Office Action Summary

10/078,601

REN ET AL.

DETAILED ACTION

FIG. 5

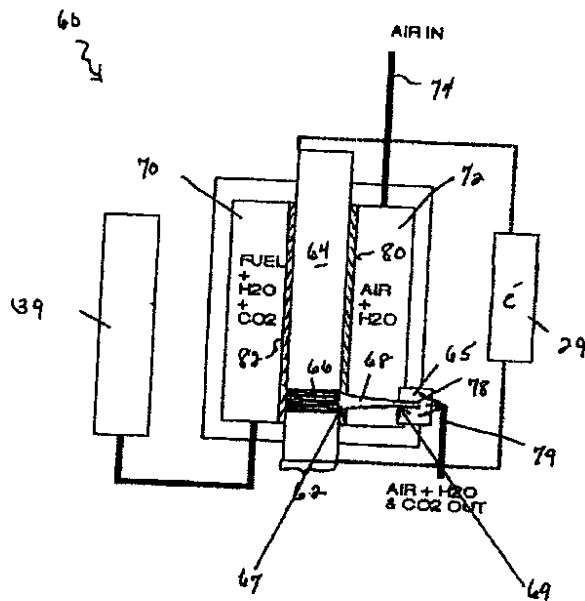
Figure 5 below depicts a passive control system using gas produced in the anode chamber for removing water from the reactive sites in the cathode chamber (SECTION 0085).

As apparent from Figure 5 and Corey et al's disclosure of SECTIONS 0014, 0017 and 0020), this fuel cell system: i) can be provided with a gaseous effluent port located in the anode chamber in close proximity to the anode side of the membrane electrolyte; and ii) does not have any liquid exit port in the anode chamber per se. Thus, it has a liquid closed volume anode chamber, and no anode liquid recirculation. These features act as a gaseous anodic product removal component. This structure also encompasses the absence of any water external pumping and/or active water removal element.

As previously mentioned, the fuel cell system of **Figure 5** above represents a passive fuel cell system (SECTION 0085): *Thus, it operates without external pumping of cathodically-generated water and without active water removal elements.*

As apparent from Figure 5 and Corey et al's disclosure of SECTIONS 0014, 0017 and 0020 and 0026, this fuel cell system: i) can be provided with a gaseous effluent port located in the anode chamber in close proximity to the anode side of the membrane electrolyte; and ii) does not have any liquid exit port in the anode chamber per se. Thus, it does have a liquid closed volume anode chamber, and no anode liquid recirculation.
